M4 Junctions 3 to 12 Smart Motorway

Non-Material Change Junction 11 No Through Junction Running Technical Note

Document Number: HA514451-CHHJ-GEN-SZ_ZZZZZZZZ_Z-TN-KK-0010

April 2022

Figure 1 Junction 11 Eastbound AM peak flows

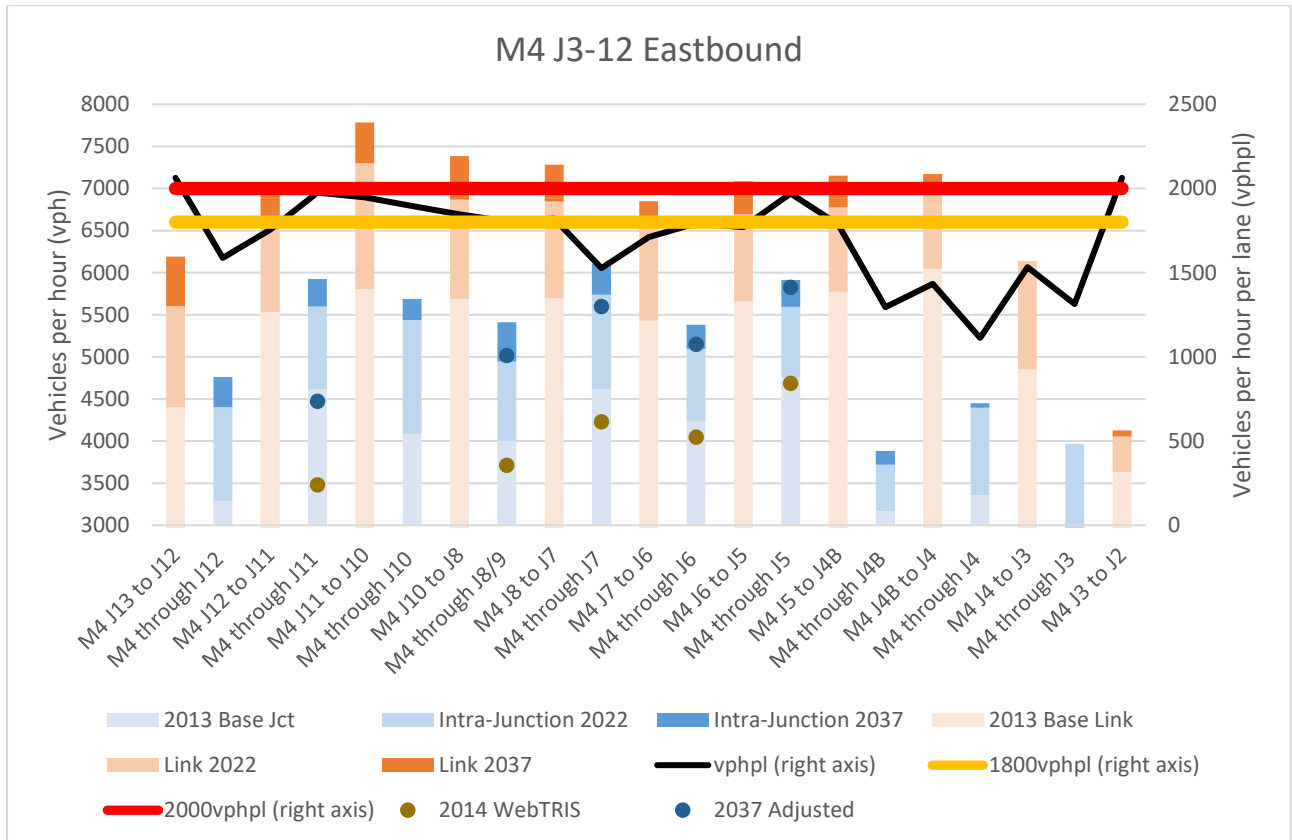
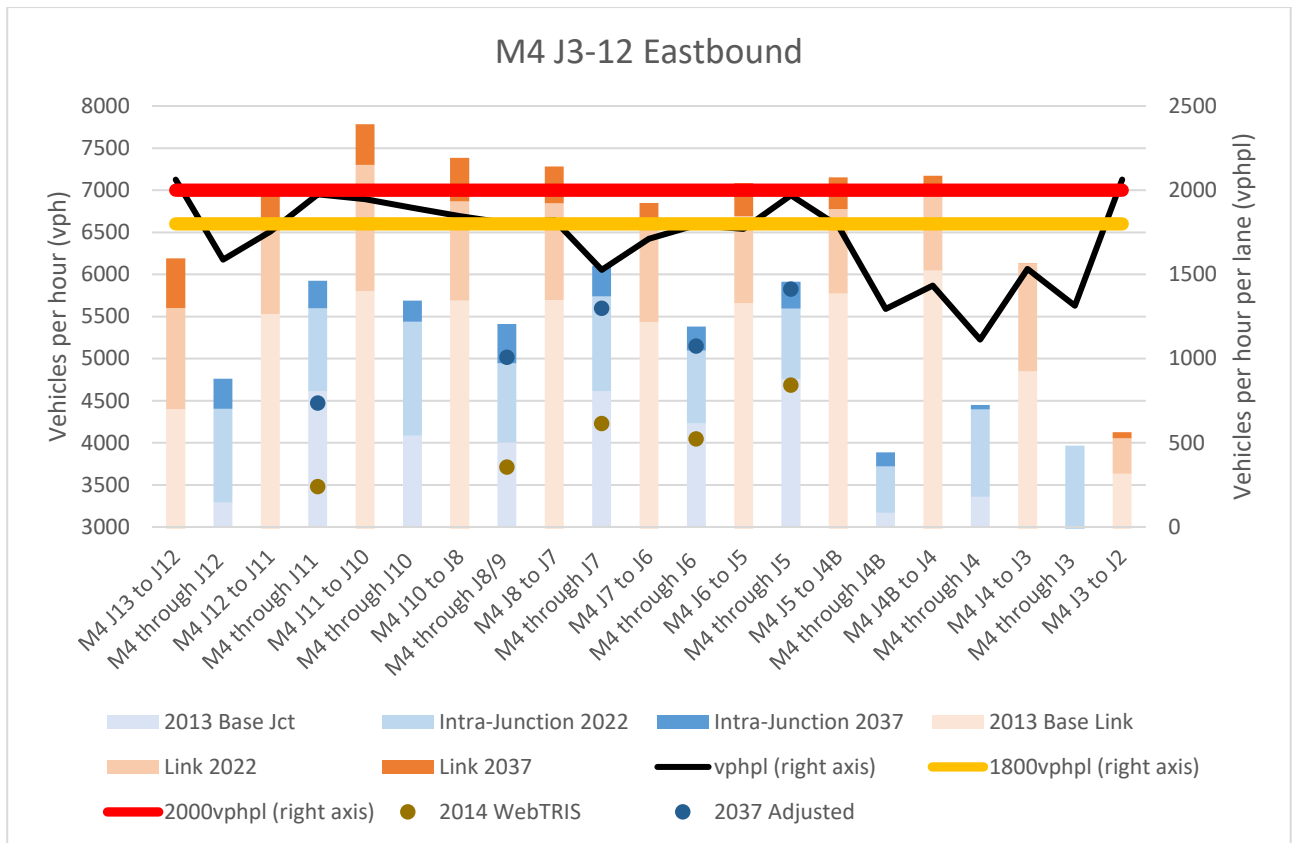
The traffic model data indicates intra junction flow without TJR (three lanes) will be 5600vph (i.e. less than 2000vph per lane) compared to 5835vph with TJR in the opening year, and 5925vph (i.e. less than 2000vph per lane) compared to 6100vph with TJR in the design year. The observed intra junction flows from WebTRIS loop data from 2013 & 2014 are 1130vph (24%) lower than the base year traffic model. Similarly, the 2013 & 2014 observed merge and diverge flows are approximately 800vph higher than the base year in the traffic model. Given this significant disparity, WebTRIS data from 2014 to 2017 has been checked to determine that this is not a temporary irregularity, and all have been found to be consistent with the 2014 data. The combined slip road and intra junction flows are also consistent with upstream and downstream mainline flows giving good confidence to this data. A simple adjustment of 24% reduction to the traffic model forecast flows would result in opening year flow of 4256vph (1419 vph per lane) and design year flow of 4503vph (1501vph per lane), both of which are well within the capacity of a No TJR layout.

In summary, the proposed No TJR layout is operating within capacity limits and has potential safety benefits for road users approaching this junction.

Figure 2 Westbound PM peak flows

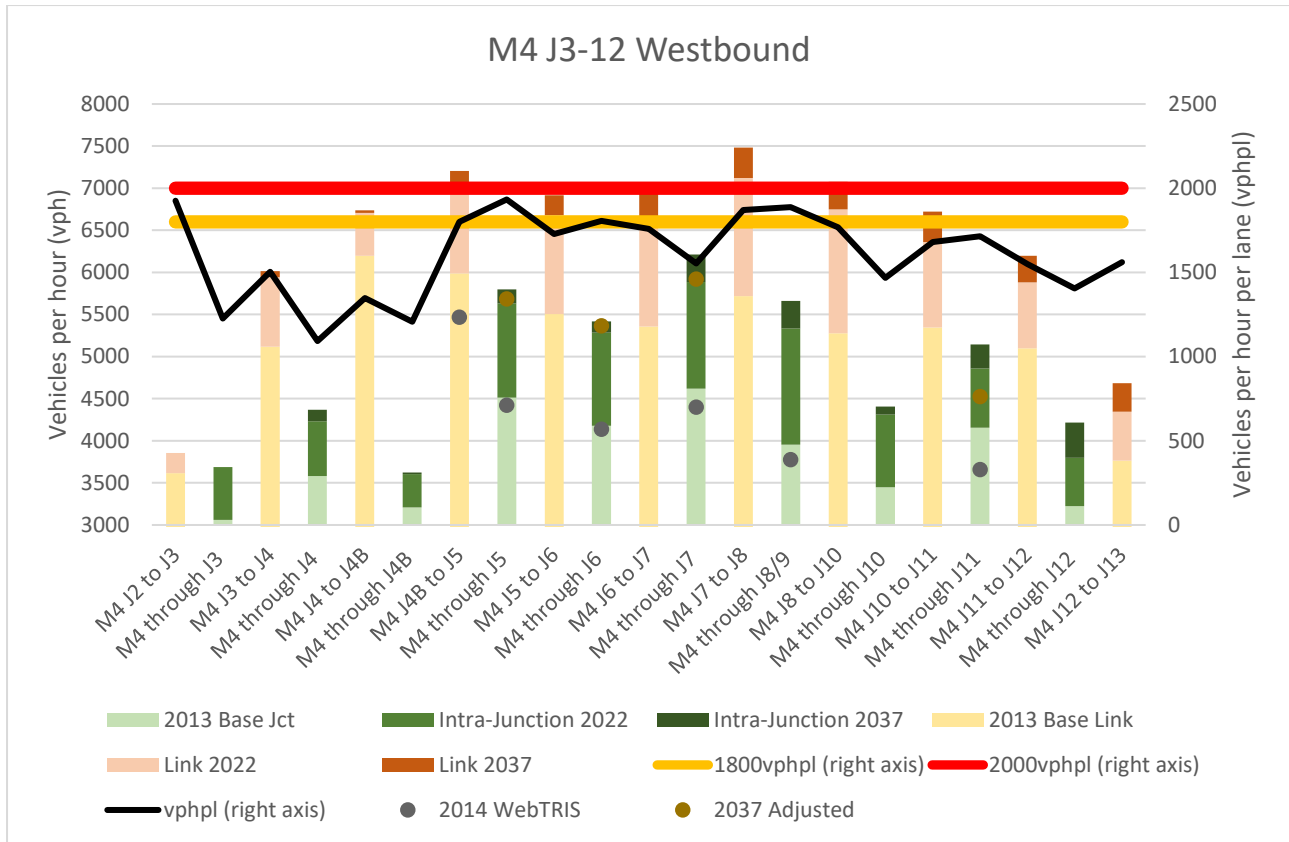
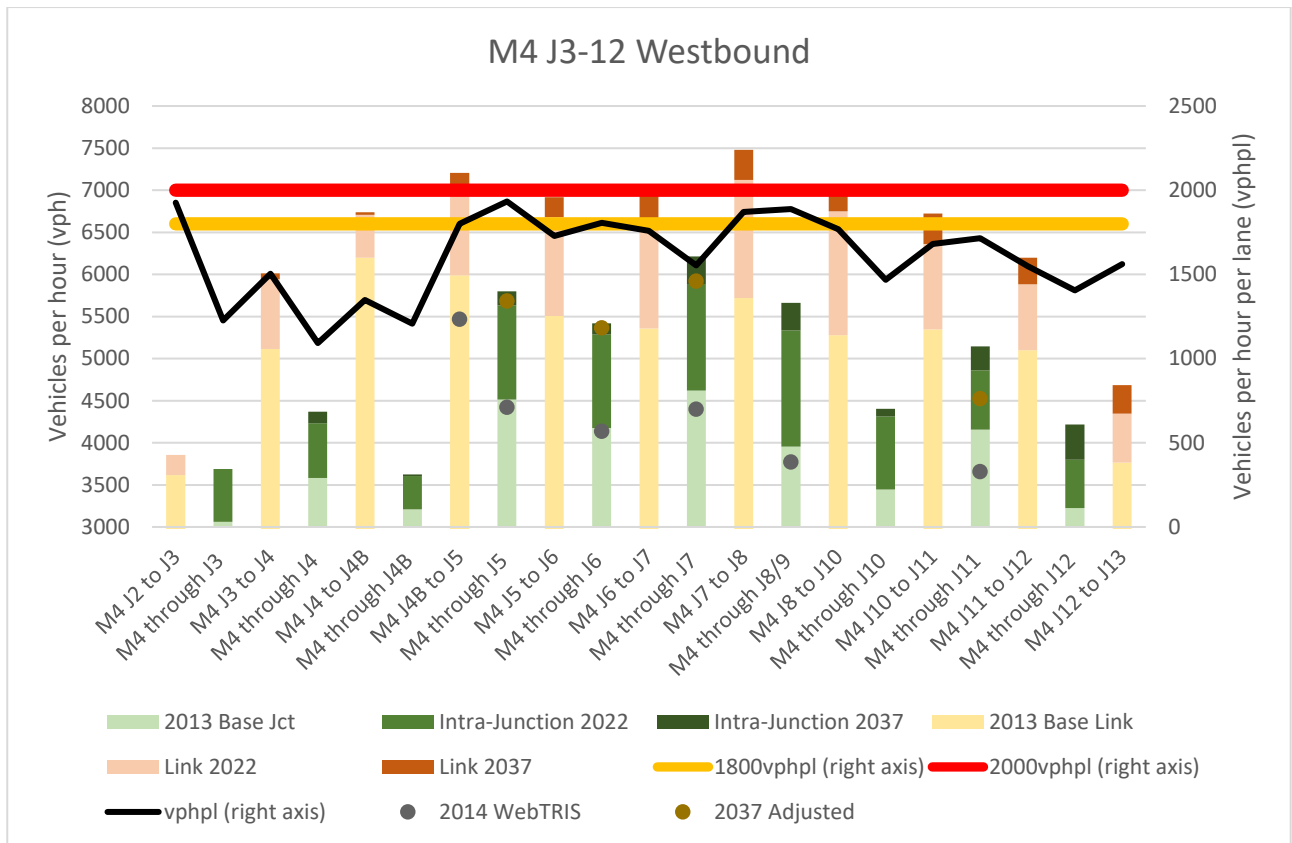
The traffic model data indicates intra junction flow without TJR (three lanes) will be 4860vph (i.e. less than 1800 vph per lane) compared to 4910vph with TJR in the opening year, and 5145vph (i.e. less than 2000 vph per lane) compared to 5220vph with TJR in the design year.

Figure 3 Schematic showing layout of junction 11 with TJR

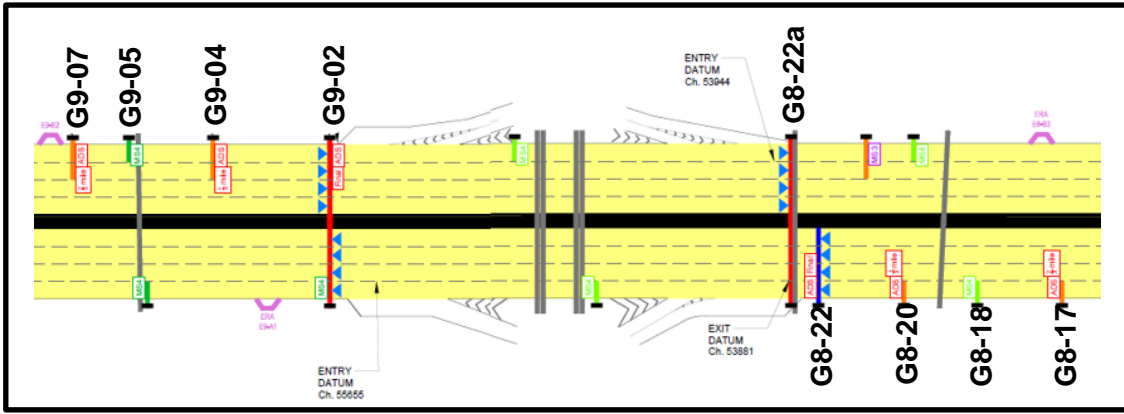
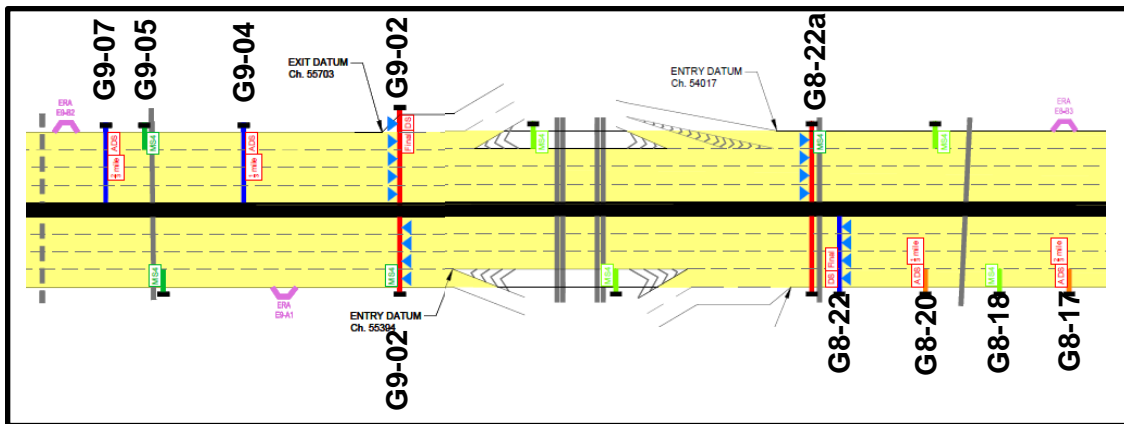
The gantry design concept for No TJR is to provide both ahead and exit Advance Direction Signs (ADS) at all diverges. These are essential at two lane ghost island diverges (Type D) to adequately inform road users of the road layout and to optimise lane usage. Therefore, the provision of ahead and exit ADS will require some changes of gantry type from short span cantilever to long span cantilever or super-span portal. Furthermore, the locations of gantries are primarily set by the datum point of the merge/diverge lanes at the junction, which has moved as a result of no longer implementing TJR. As a result, the gantry arrangement associated with junction 11 has required amendment.

This includes accounting for the fact that gantry positions were subject to limits of deviation outlined in the DCO as granted in September 2016 and some of the new locations are outside of these limits as shown on the Works Plans associated with the made DCO, noting that there is no limit of deviation for existing gantries which cannot be reused and need to be relocated.

Figure 3 shows a schematic of the previously proposed location/order of gantries on both approaches to junction 11, whereas Figure 4 shows the new proposed layout of junction 11 (with No TJR).

The details eastbound and westbound gantries are provided in Table 2 and Table 3 respectively. The changes to gantry location between TJR and No TJR are shown.

Figure 6 Noise level changes (DS22 No TJR) minus (DS22 With TJR)

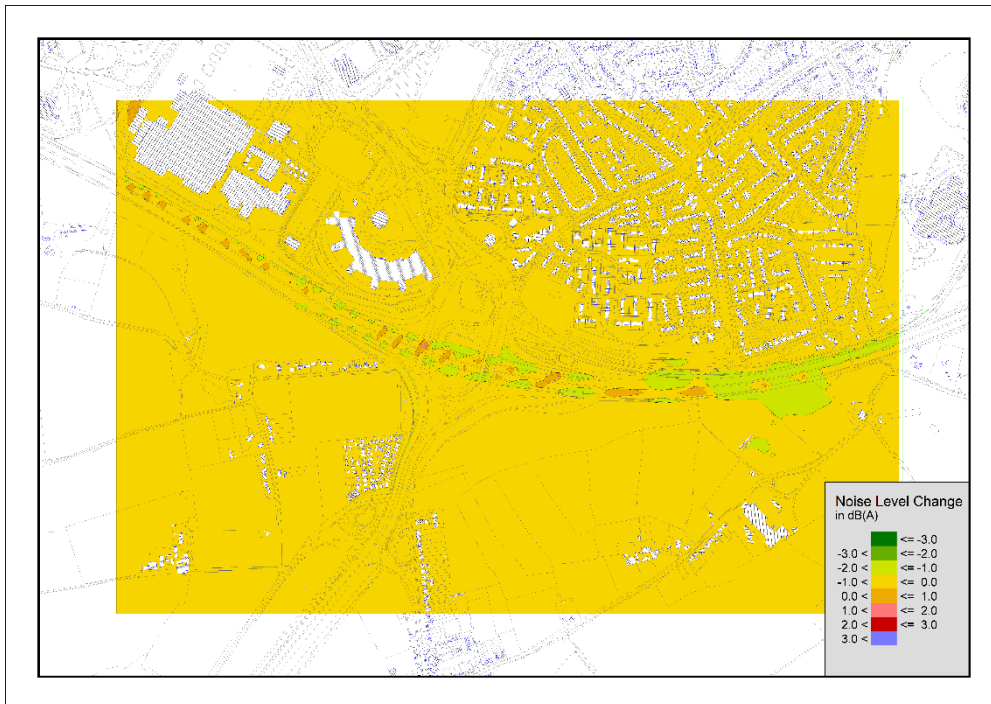
It can be seen that there are generally negligible noise level decreases across the surrounding area as a result of adopting No TJR when compared with TJR.
